Project Name: Dockside Flats

Master File: <u>17-4634</u>

Concept Design Review

CITY OF OLYMPIA BASIC COMMERCIAL DESIGN CRITERIA Chapter 18.110

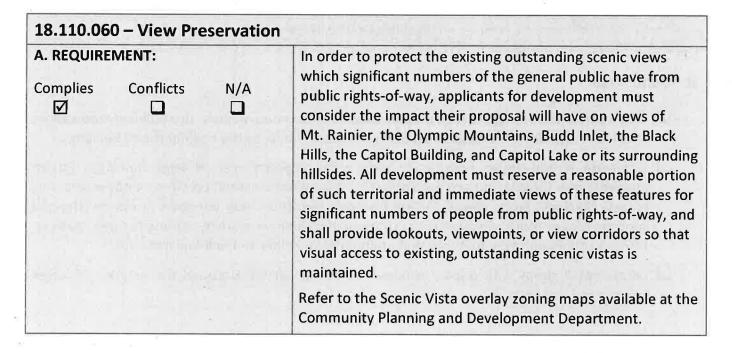
Metal trellises are proposed on the south and north elevations to screen on-site parking (see page A302, Attachment 4).
